Historic Zoning Commission

October 17, 2024

Case # HZ-23-128

Description of proposed project: COA Revisions: Roof, Porch, Gutters

Federal Conductors/Scupper Boxes

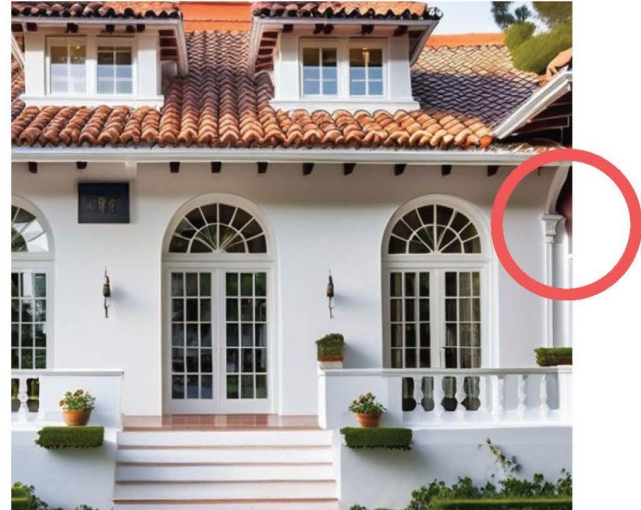
6. Gutters and downspouts are important to the appearance and maintenance of roofs. The gutter system should be preserved or repaired with matching materials when possible. If replacement is necessary, the materials should be appropriate to the building on which they are located and have the same size, shape, texture, and material as the historic gutter and downspout systems. **The applicant is proposing to replace the existing gutters. Existing is a mix of partial copper on the roof and aluminum gutters painted green. Applicant is proposing white aluminum gutters and removal of the federal conductors.**

proposed patio dimensions

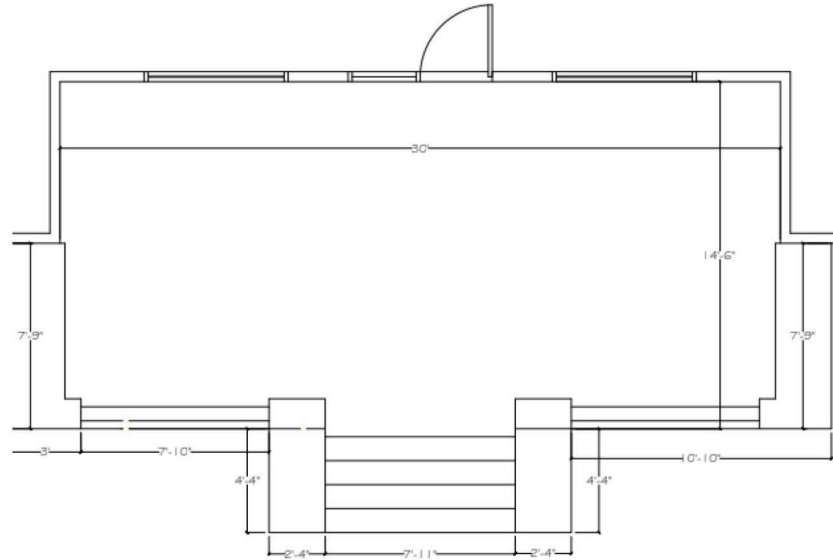
1. Porches and steps that are appropriate to the building and its development should be retained. Porches or later additions reflecting later architectural styles are often important to the building's historical integrity in which case they should be retained. **The applicant is proposing to increase the depth of the existing porch with concrete.**

2. Original details and shape - width, roof height, and roof pitch should be retained. **The applicant is proposing to expand the porch with concrete and install a new balustrade and walkway. The renderings show the removal of the existing balustrade. Applicant to confirm and explain proposed materials (rendering and material list are different) The renderings show a different design for the stairs. Applicant to confirm details.**

3. Original porch materials should be preserved or replace when beyond repair. Such materials include wood, terra cotta, tile, slate, brick, marble, stone, and stucco. Other materials may be substituted for these when it is not economically feasible to replace or repair with original materials. **Applicant is requesting to extend porch with concrete and not replace the existing red terracotta tiles.**

4. Original porch details, such as columns, balusters, handrails, pediments, brackets, and roof detail, should be preserved or replaced when beyond repair. **The applicant is proposing to expand the porch with concrete and install a new balustrade and walkway. The renderings show the removal of the existing balustrade. Applicant to confirm and explain proposed materials. The renderings show a different design for the stairs as well. Applicant to confirm details.**

PROPOSED SITE PLAN

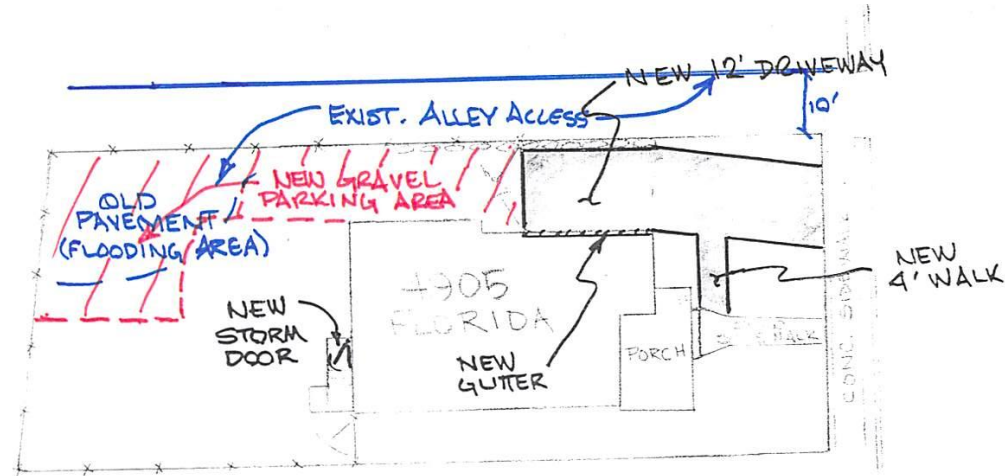
B. Which are new, should be located at the rear with access from the alley. **The proposed driveway and parking area are to the side of the dwelling immediately adjacent to an existing alley.**

C. In the front or side yards should be of gravel (white or pea gravel), concrete, or concrete tracks (narrow strips). Blacktop or asphalt driveways may be approved but this material is not traditional to the neighborhood and should be avoided. **The applicant has proposed concrete or gravel for the new driveway and parking area.**

D. Should have their parking areas located in the rear yard nearer the alley than the building and screened with hedges, shrubs, or fences where noticeable from the street. **The proposed driveway and parking area are to the side of the dwelling immediately adjacent to an existing alley.**

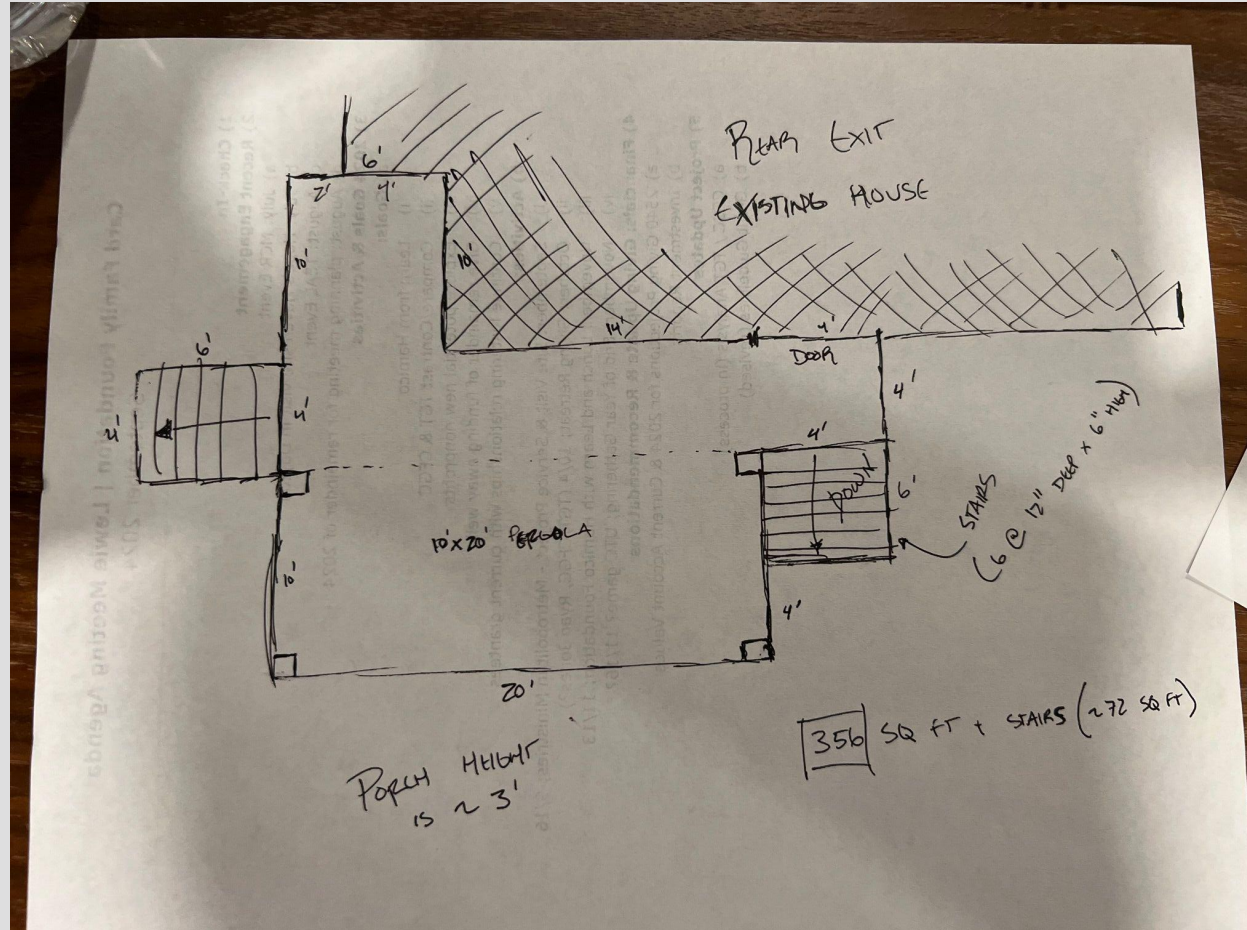
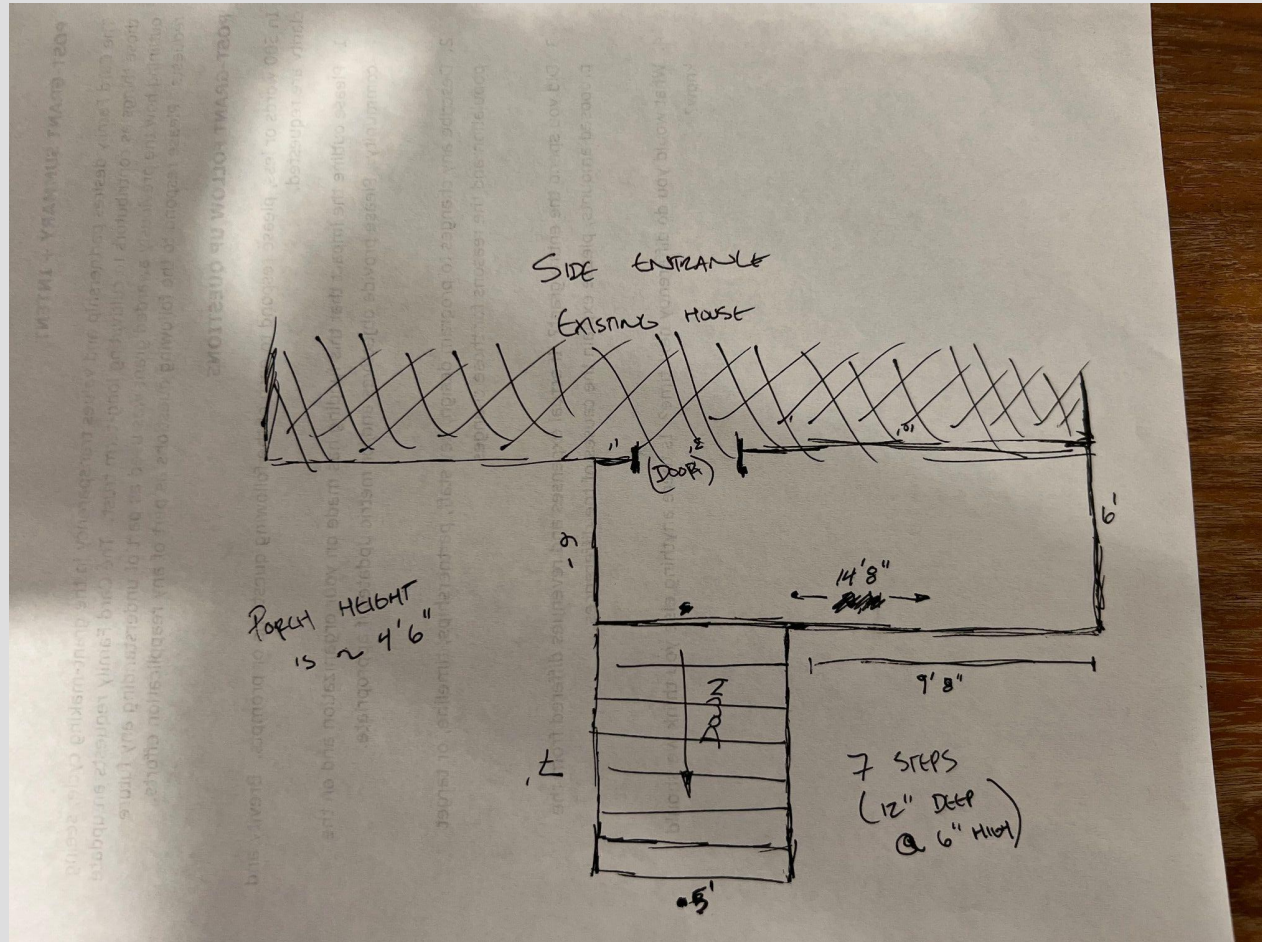
- A. Should be located at the rear of buildings. If built on the side of a building the deck should be screened from street view with fencing and/or native evergreen plants and shrubs. **The applicant is proposing a deck on the side and rear of the recently approved addition. The applicant did not note if there is existing screening for the side porch. The side porch may encroach into the setback off of W. 51st Street. If so, a variance from the Board of Zoning Appeals would be required.**

- B. Should be stained or painted to match or blend with the colors of the building if readily visible from a street view.
- C. Should be simple rather than ornate in design. If readily visible from the street, wood decks are recommended to have square wood balusters set no more than three inches apart. Balusters should be no more than 2” in width and depth. **The drawings seem to show square balusters. Applicant to discuss dimensions and materials. Materials also show horizontal screening beneath the proposed porch.**
